September 22, 2022

RE: Scoping Comments for Sienna Solar and Storage Project in Lucerne Valley

Figure 2: Visibility of proposed Sienna Solar and SCE Substation Projects

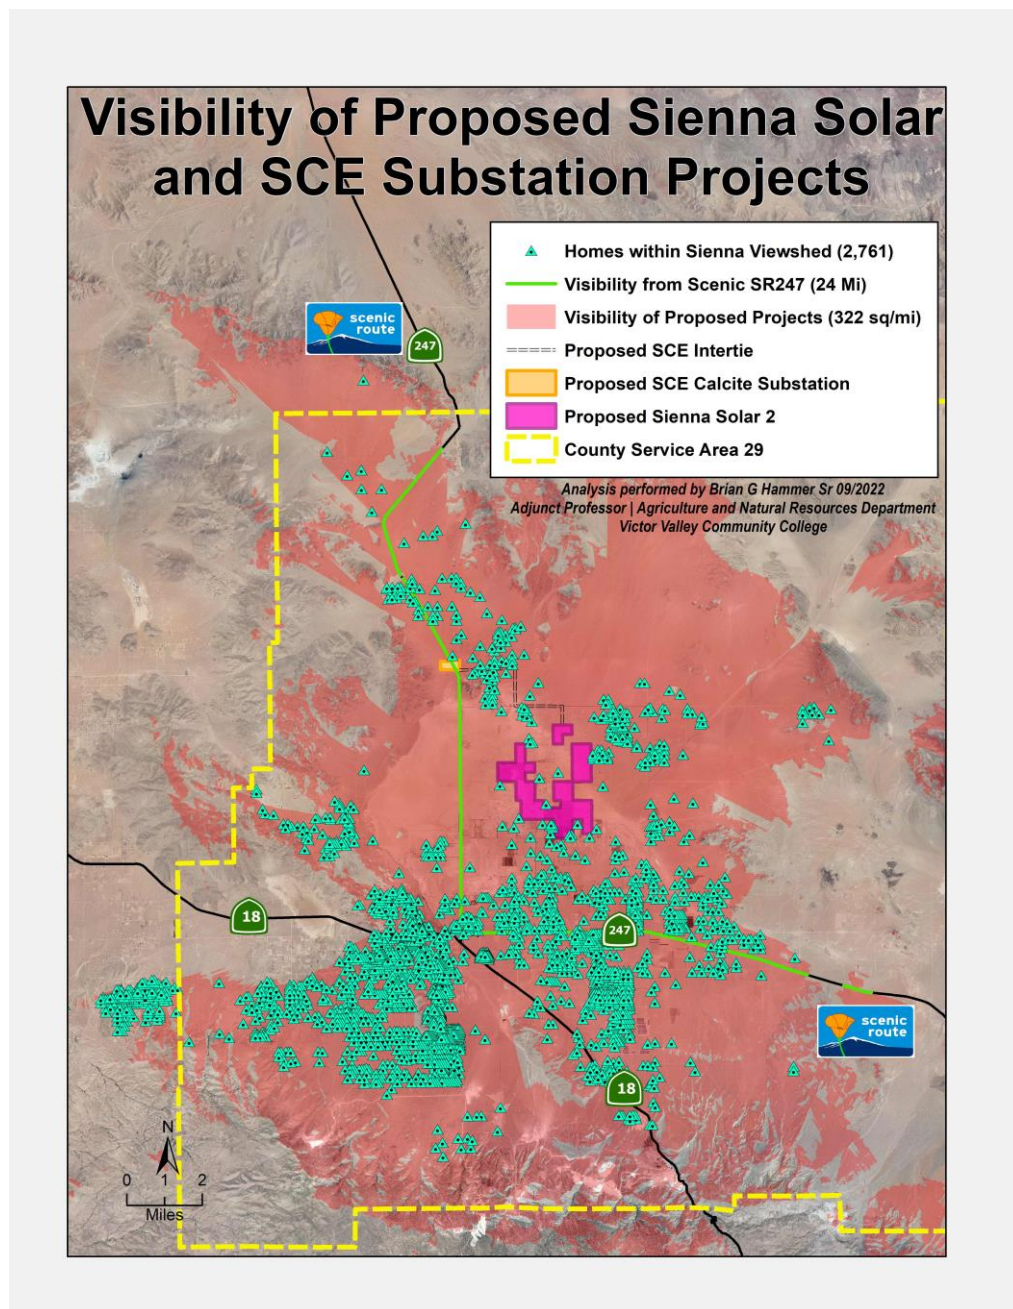
The Project footprint would industrialize an area of ~5 square miles of land east of SR 247. It will be visible for 322 sq. /mi, and within the viewshed of 2,761 homes,

See Figure 2: Visibility of Proposed Sienna Solar and SCE Substation Projects (page 4) and Figure 10 Appendix A

Because of the scale the homes look close together but in reality, and factoring in the history of homesteading back to the 1870s and the later Small Tract Act (5 acre Jackrabbit Homesteads 1938-1976) most homes are on 1 to 5 acres and larger. See Figure 10 Appendix A

Comment: The Impact of the proposed Project is potentially significant and all mitigation measures must take into consideration the whole action involved, including off- and on-site.

Figure 3: Soils with potential for dust issues

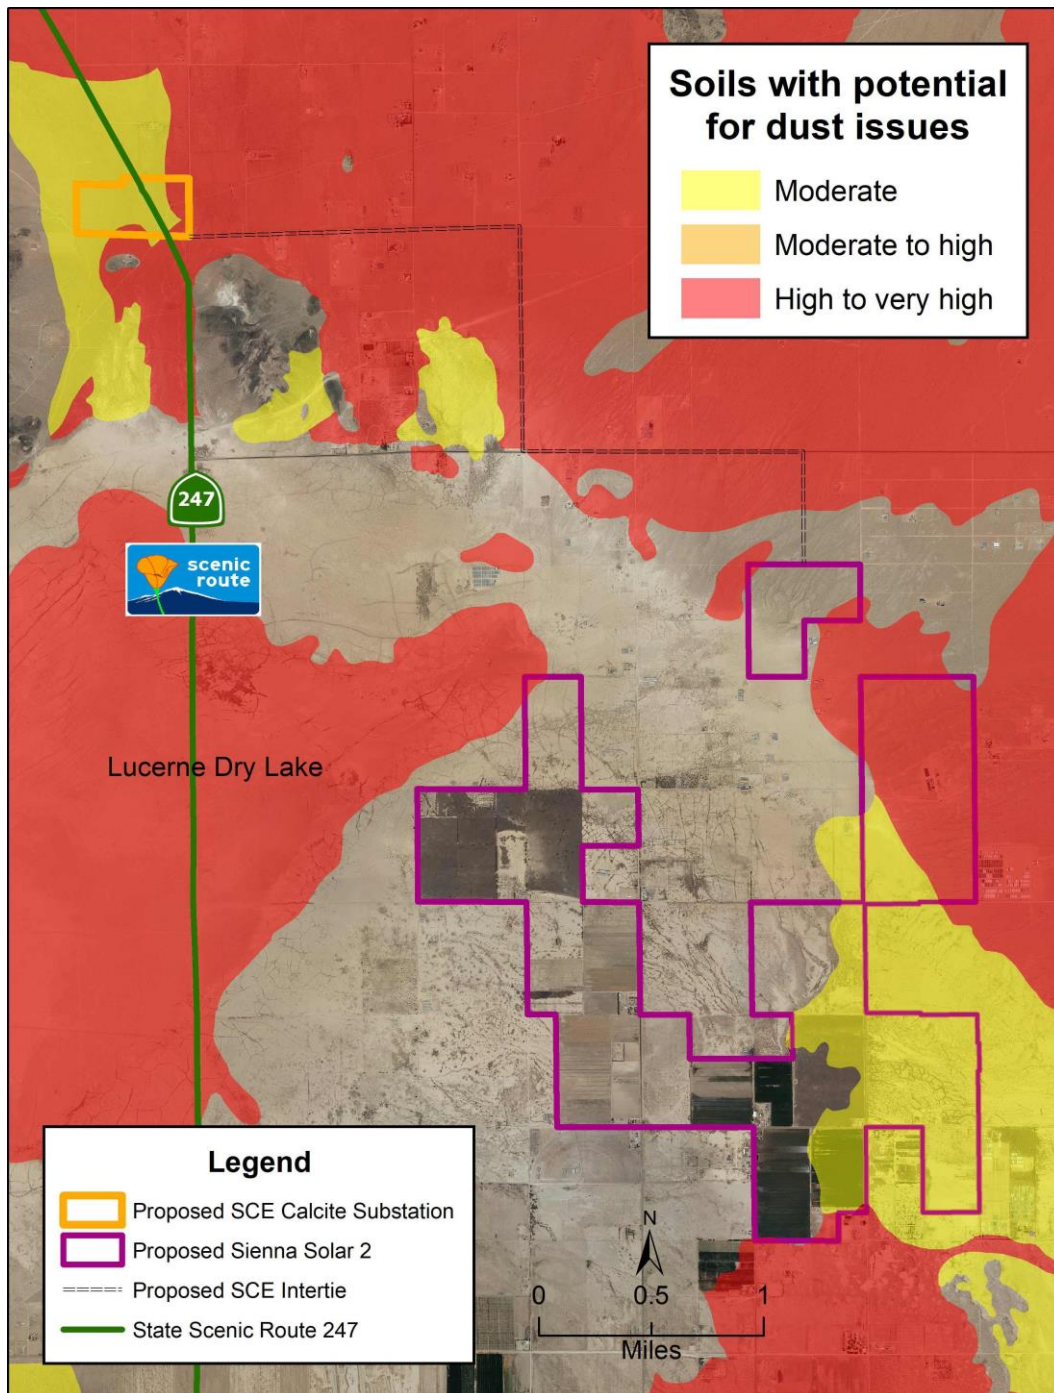
As we will see (Figure 3, page 6), when disturbed the Sienna 2 project area soils will release considerable PM 10 and PM 2.5 exposing a large number of sensitive receptors (Figure 2) to substantial dust pollution resulting in significant health impacts. See the Newberry Springs blog referenced below.

Figure 3: Soils with potential for dust issues illustrates how wise 8ME was to move Sienna 1 east off the dry lake proper. The beige color in Figure 3 is the shrinking clays found at the upper edges of Pleistocene lakes. Following storms, as the slimy clays dry out, huge fissures form which swell and heave making it difficult to travel across. A thick gravel surface will be required for vehicles traveling across the project area. The agricultural parcels will lose their cover crops along with the moisture and roots which hold the clay surface in place.

Figure 4: Lucerne Lake Watershed and Groundwater Basins

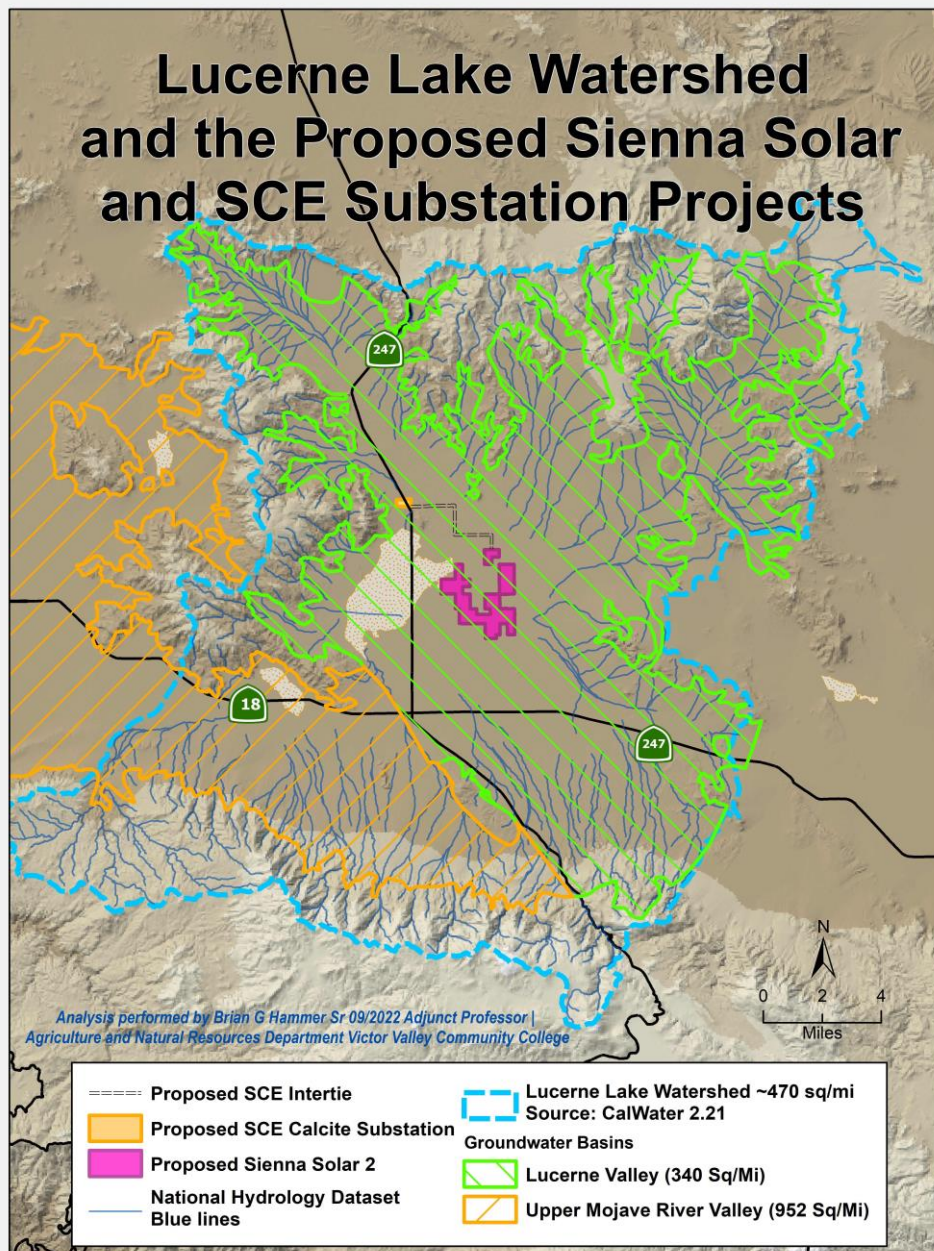
Comment: Local residents relying on wells must be protected. Water for construction, operation, and decommissioning (unless the project is continued) must be accounted for. Chuck Bell, President of LVEDA, has pointed out that estimates for previous projects primarily for soil stabilization have been a fraction of what was actually used or needed. The EIR needs to be realistic about water and dust control. Locals have the experience to know when soil stabilization and water calculations are based on the best available information.

Dust control and water availability, including recharge have potentially significant impacts from the proposed Sienna 2 project. Before any approval of the CUP 8ME must show they have the water rights and/or will serve letters to provide all the water required for the duration of the project without drying up neighboring wells. This information must be publically disclosed.

Figure 5: Plan Area for the Apple Valley HCCP

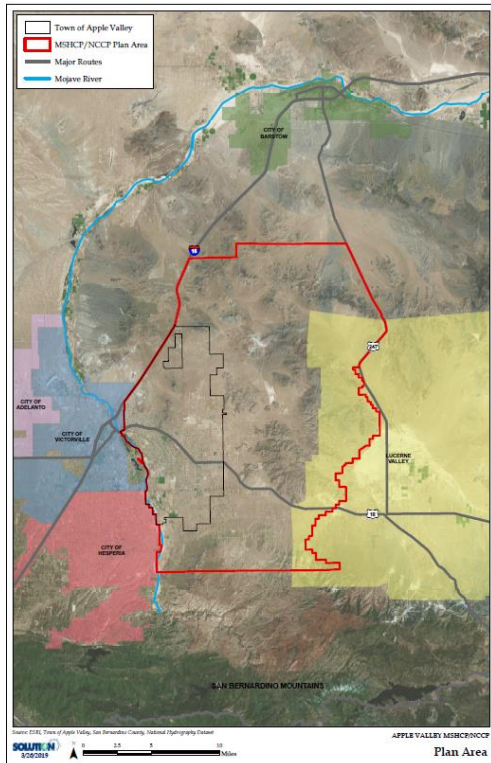
The Plan Area does not overlap with the proposed Sienna 2 site but the covered species are not impressed with artificial boundaries and should be studied for overlap with the Sienna 2 site in the EIR. See Table 1 below for the list of covered species especially those that are threatened, endangered, or candidate species under federal and state laws.

Figure 6: Terrestrial Connectivity

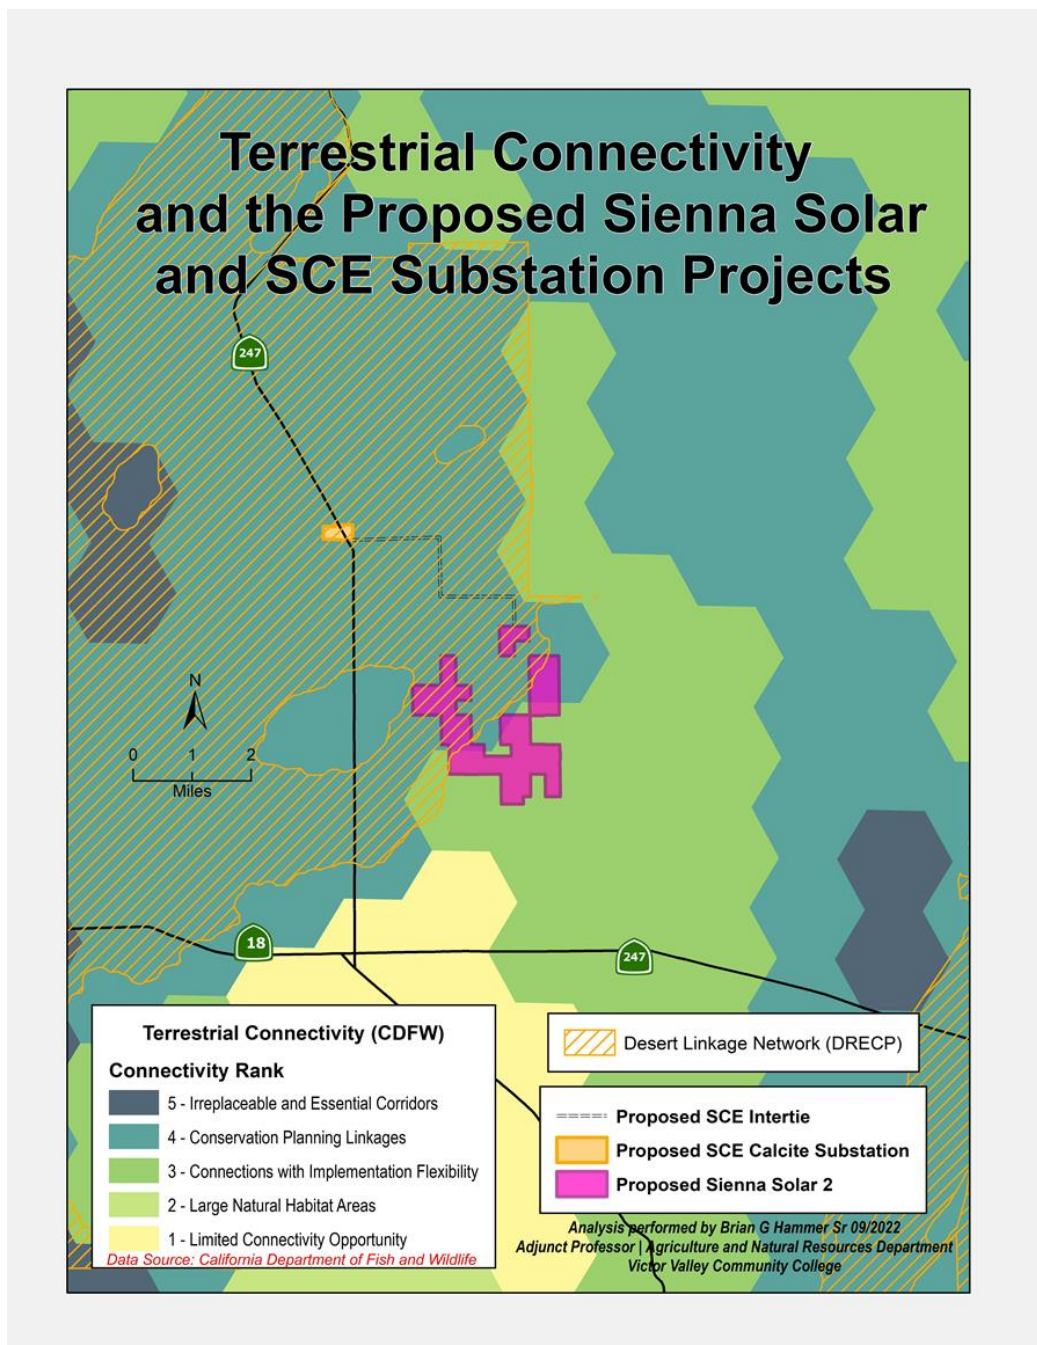
Figure 6: Terrestrial Connectivity (page 10) places the proposed Sienna 2 within both Connectivity Rank 3 and 4 as developed by California Department of Fish and Wildlife. It is also within the DRECP Desert Linkage Network.

Comment: The EIR must analyze the biological richness of the area and the mitigation measures proposed for Sienna 2 on- and off-site including the larger surrounding area to maintain the integrity of the connectivity between the San Bernardino Mountains and the Newberry and Rodman Mountains Wilderness Areas.

Figure 7: Cumulative Solar Projects

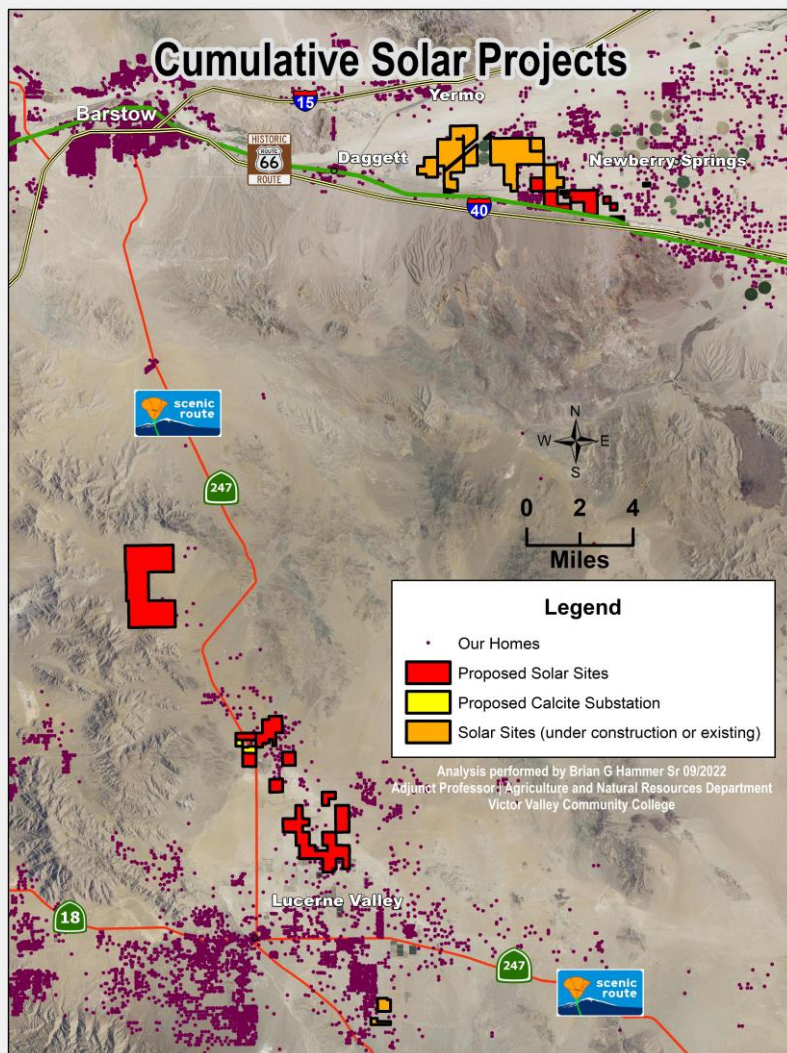
Figure 7 shows the existing and planned solar projects and the SCE Calcite Substation.

The four Projects in northern Lucerne Valley depend on the approval and construction of the Calcite Substation for energy distribution. The EIR for Calcite is connected to Stagecoach Solar with approval by the CPUC before construction. Stagecoach is on State Lands and California State Lands is the Lead Agency.

Comment: Figure 7: Cumulative Solar Projects (page 12) is included to assist with the cumulative analysis on the environment and on the SDAC communities of Lucerne Valley and Newberry Springs. From the personal investment of homeowners, health effects from diminished air quality, loss of community tourist revenue, the personal loss of viewshed and dark night skies, and the change in day-to-day living that the multiple effects will change many lives. Watch again the Newberry Springs blog documenting Daggett Solar construction.

Figure 10: Proposed Sienna Projects Compared

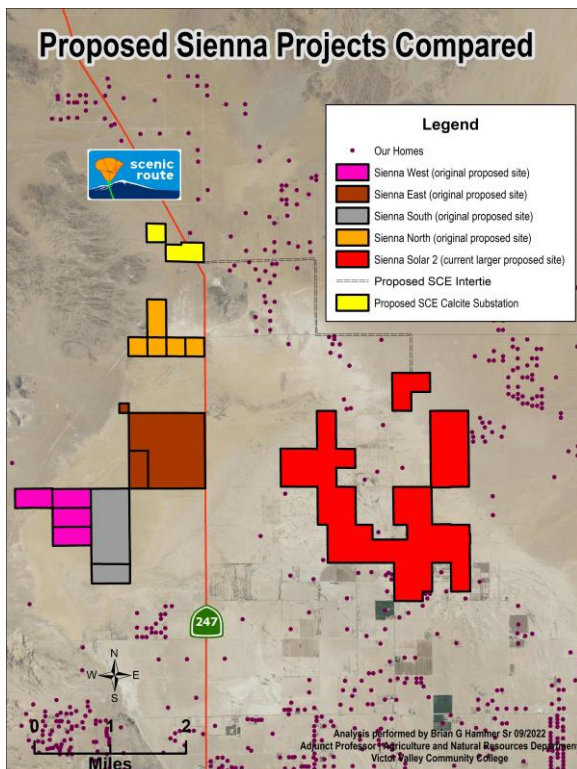
CEQA Environmental Factor IX. LAND USE AND PLANNING: a) The large footprint Sienna 2 physically divides the established community as clearly visualized in Appendix A Figure 10.

The map demonstrates the degree to which the original Sienna 1 Project, even after the additional acres were added, did not physically divide the community of Lucerne Valley as the proposed Sienna 2 does.
